CITY OF SAN ANTONIO

VARIANCE REQUEST ANALYSIS

TPV 21-033

Project:	Davis Ranch Subdivision Unit 1
Address:	General located north of the Swayback Ranch and Galm Road intersection
A/P #/PPR #/Plat#:	AP#2172685/Plat 160320
VR Submittal Date:	1/21/2021
VR Submitted by:	Mr. Javier Castello, PE with Cude Engineers on behalf of Joseph Epp with Pulte Homes
Issue:	Below 80% significant tree and 100% heritage tree preservation within 100-Year Floodplain and Environmentally Sensitive Area (2010 Ordinance)
Code Sections:	Unified Development Code (UDC), Section 35-523 (h)
Prepared By:	Herminio Griego, Assistant City Arborist

TP-2

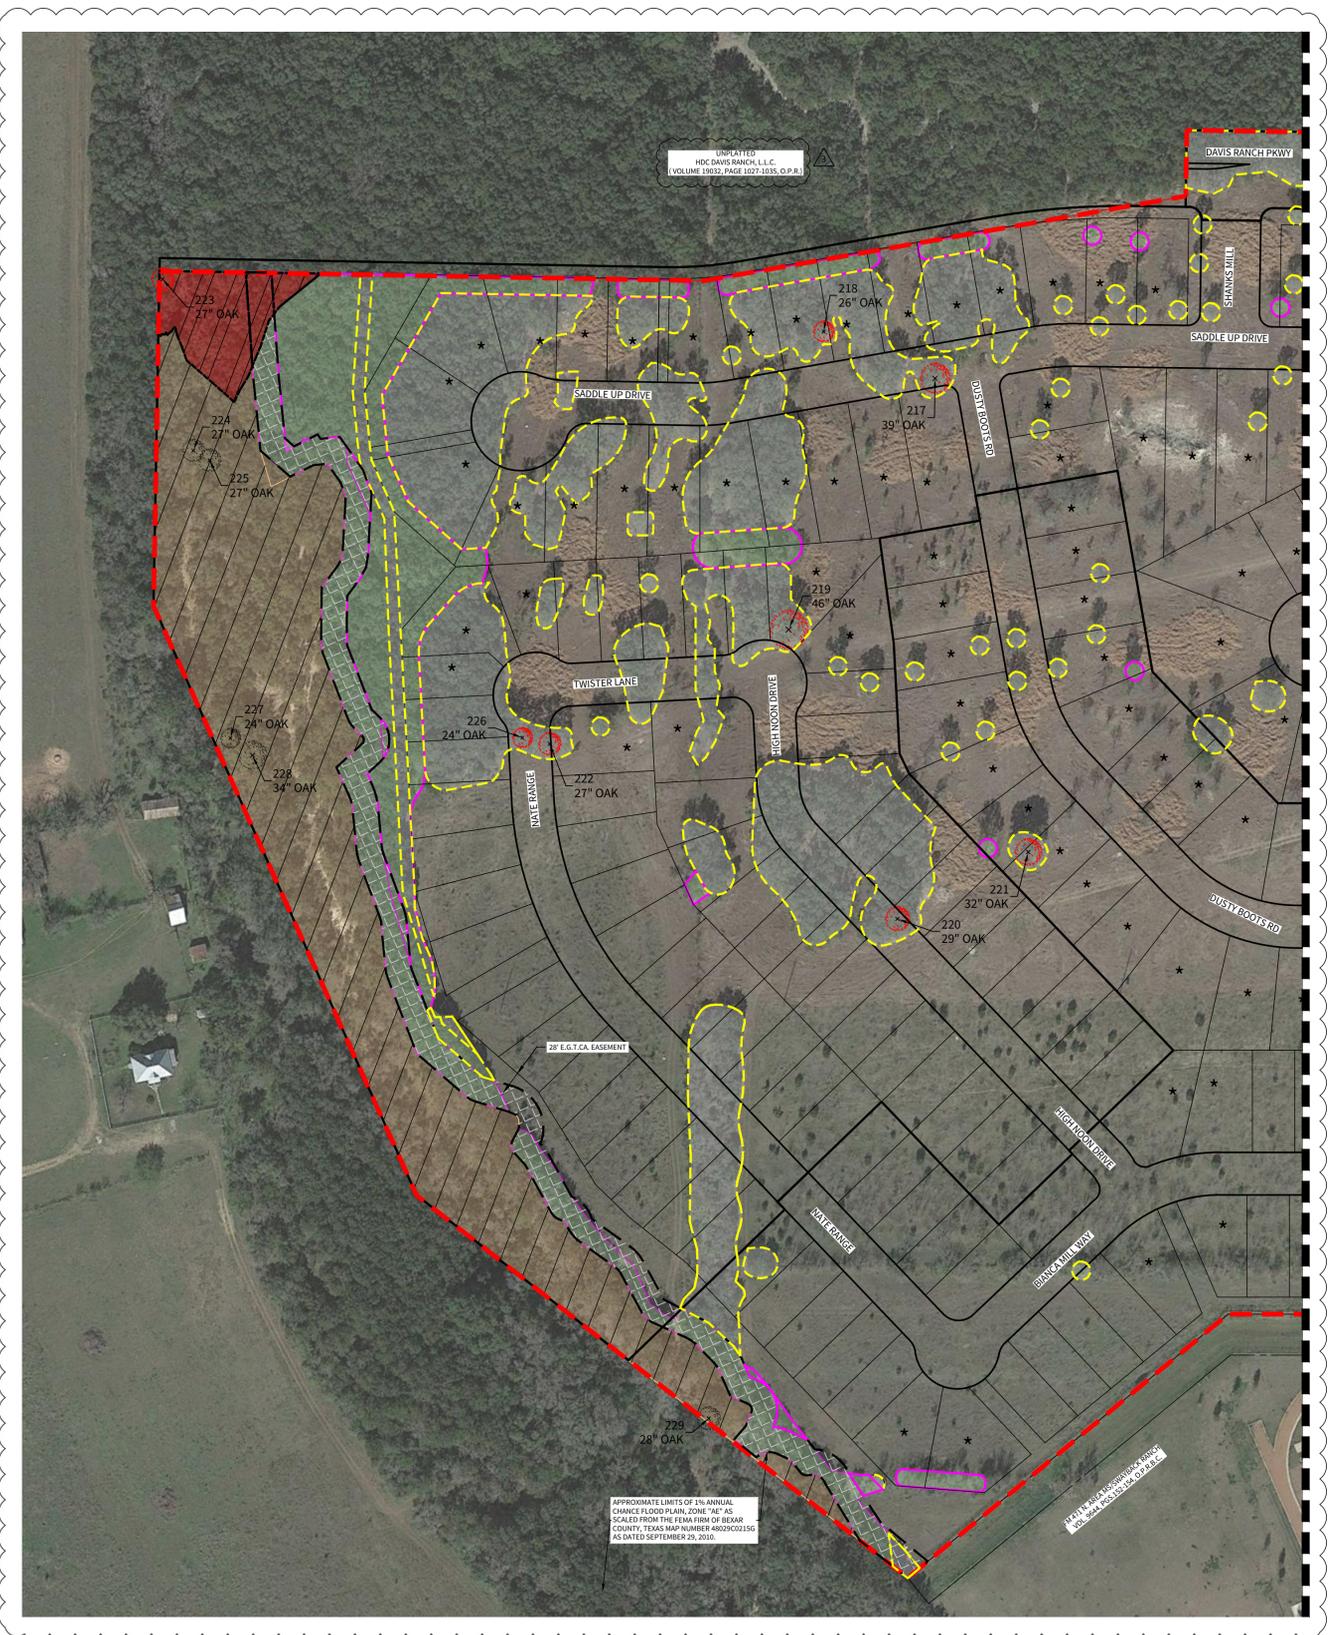
The applicant is requesting a Variance Request to mitigate for removal of heritage trees in excess of the 100% preservation requirements within the 100-year Floodplain in place under the 2010 Tree Preservation Ordinance for construction of the Davis Ranch Subdivision Unit 1. DSD staff does agree with the applicant's request to mitigate for the removal of heritage trees below 100% for the following reasons:

1. *Existing site conditions* – Davis Ranch Subdivision Unit 1 currently has an approved tree plan, AP#2172685, which was approved on 11/22/2016 and followed all the required preservation and planting requirements. McCrary Tract Subdivision is currently being developed to the west of Davis Ranch Unit 1 and requires Davis Ranch street to cross through the floodplain and into the proposed McCrary Tract development. The proposed floodplain crossing requires a culvert crossing consisting of 10-8'x8' box culverts. The construction and grading required to install the 10-8'x8' box culverts will result in the removal of a 27" Live Oak.
 - a. Floodplain Heritage Inches = 139 inches total, 27 inches removed, 112 inches preserved, 80.5% preservation ratio, 81 inches of required mitigation

2. *Tree mitigation*– The total mitigation required for removing the heritage tree within the floodplain is 81 caliper inches. The owner proposes to mitigate by planting (35)-2 inch caliper trees in the Davis Ranch amenity center and (18)-2 inch caliper street trees along Swayback Ranch. The total mitigation provided is 106 inches. The 53 trees to be planted provides added species diversity to include native medium and large species trees per San Antonio Recommended Plant List.

DSD staff supports the applicant’s request to fall below 100% of heritage tree preservation requirements within the 100-year Floodplain based on the conditions of the site, design constraints, and exceeding mitigation requirements. The proposed Variance Request meets the intent and spirit of the Tree Ordinance therefore, staff recommends approval.

RECOMMENDATION: Variance Request Approval

TP-3

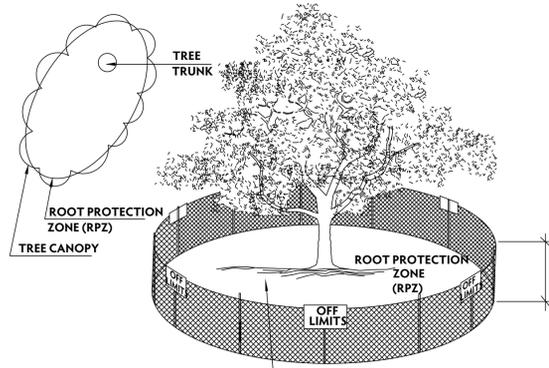
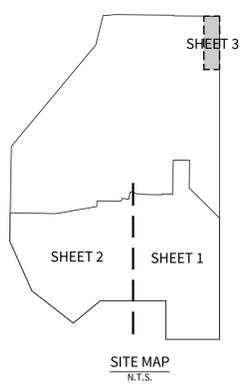
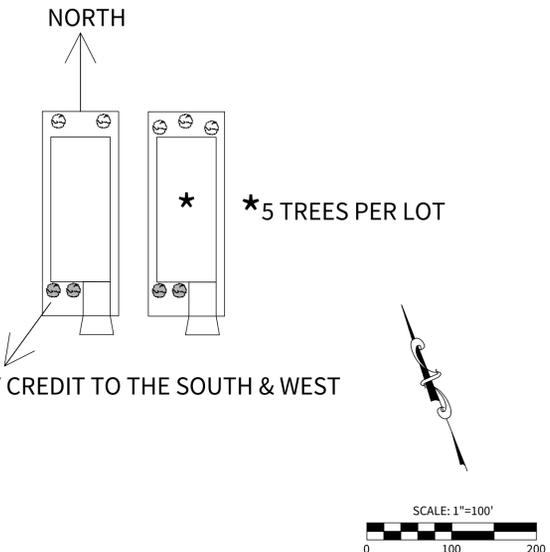
The removal of this tree triggers the need for 81 inches of tree mitigation on this tree preservation plan. To mitigate the removed trees on the site, there will be 106 inches planted within Davis Ranch Unit 1. The trees that are being planted in this unit will consist of 53 – 2-inch trees (106 total inches) in the Davis Ranch amenity center and along the Swayback Ranch right of way.
